Re: **Proposed Palmer Lake, Co - Buc-ee's**

Subject: **Traffic Impact Study Review**

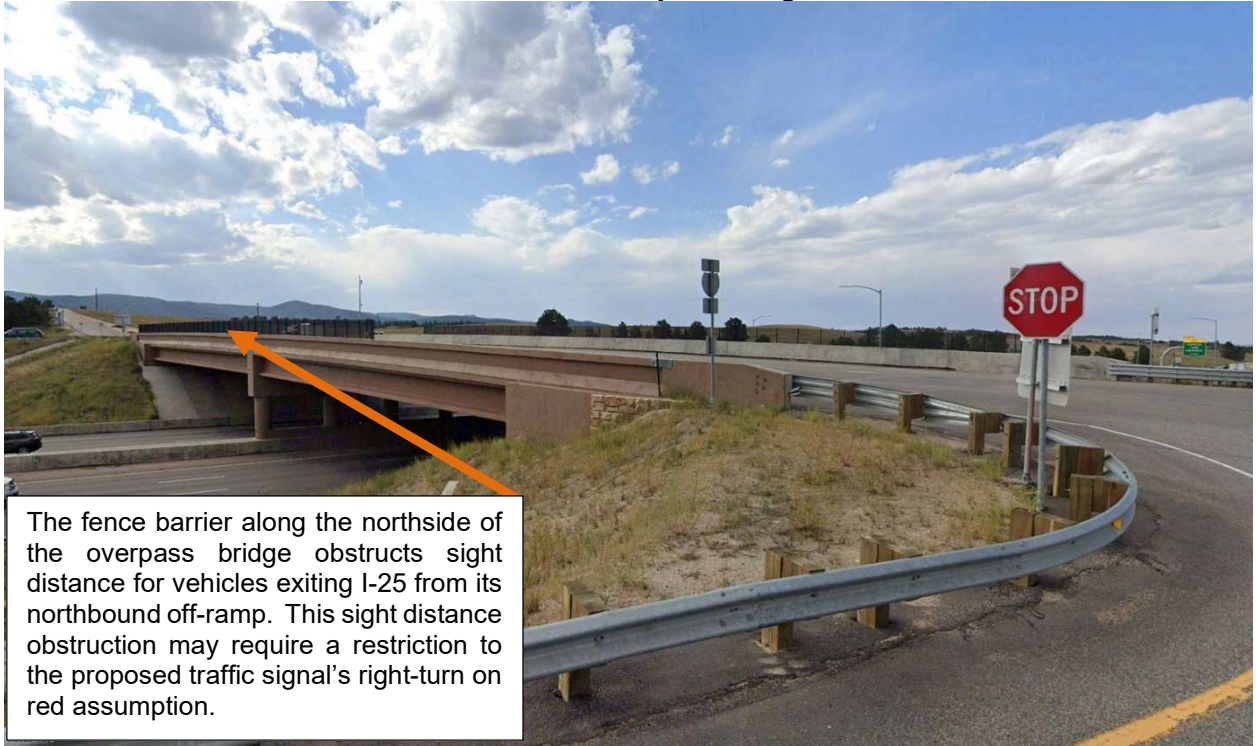
**Roadway Geometry.** The previously prepared traffic studies provided the following improvements at the I-25/County Line Road interchange:

- Restripe the existing bridge lanes to provide three (3) westbound and two (2) eastbound lanes.
- Construct an additional lane on the I-25 NB off-ramp and the I-25 SB off-ramp at their intersection with County Line Road.
- Reconstruct the eastbound approach to provide a total of three lanes at the intersection with the I-25 SB off-ramp.
- Install traffic signals on County Line Road at both I-25 off-ramp intersections.

The fifth travel lane on the interchange bridge would require the reduction of existing striped shoulders. Therefore, the lateral offset requirements from the bridge wall need to be considered to ensure proper clearance from heavy vehicles. Additionally, the alignment of the relocated through lanes with the corresponding receiving lanes would need to be reviewed.

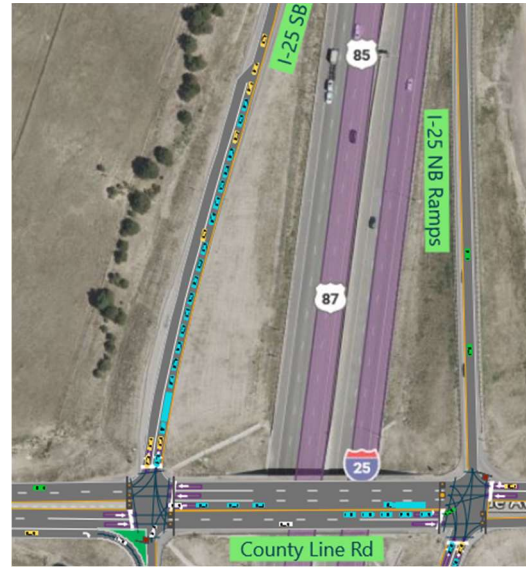
While a full analysis of the interchange and freeway operations would likely be required as part of the interchange modification process, a preliminary assessment was performed as part of this review. Specifically, the 2045 Synchro analysis from the Kimley Horn study was replicated based on the analysis worksheets and signal timing sheets provided in the report appendices. The following modifications were then made to support the SimTraffic model:

- The yellow and red times were increased from the Synchro default values (3.5 sec. yellow, 1.0 sec. red) to values (4.1-4.3 sec. yellow, 2.6 sec. red) consistent with CDOT's "Guidelines for Traffic Signal Vehicle Change and Clearance Intervals".
- Right-turns-on-Red (RTOR) was turned off for the I-25 Off-Ramp approaches to the proposed traffic signals for the sight distance constraints outlined above.
- The Link Origin-Destination settings were revised to account for the fact that few (if any) vehicles would exit I-25 at one intersection and re-enter at the adjacent intersection.

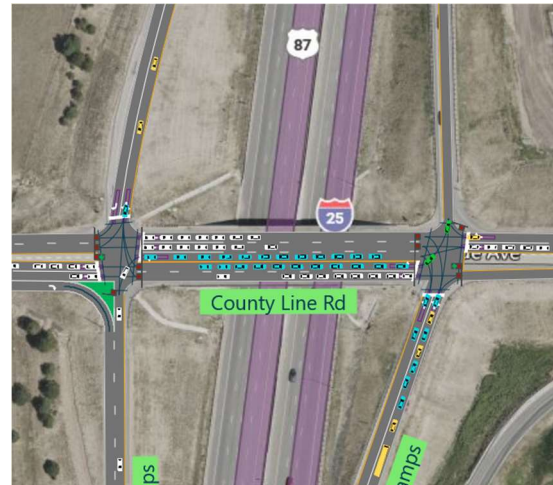
- During the PM peak hour, queues on the I-25 NB off-ramp would periodically extend to the gore point. It is noted that based on AASHTO standards and a design speed of 80 mph (posted 75 mph + 5 mph), an additional 705 feet of deceleration distance would be required to ensure mainline freeway operations are not impacted.

- The peak southbound left queue on the ramp would extend approximately 500 feet. The proposed right turn lane would need to be constructed to this length to avoid being blocked by the adjacent queue. The 705 feet of deceleration distance beyond the queue would extend to the taper area of the ramp.
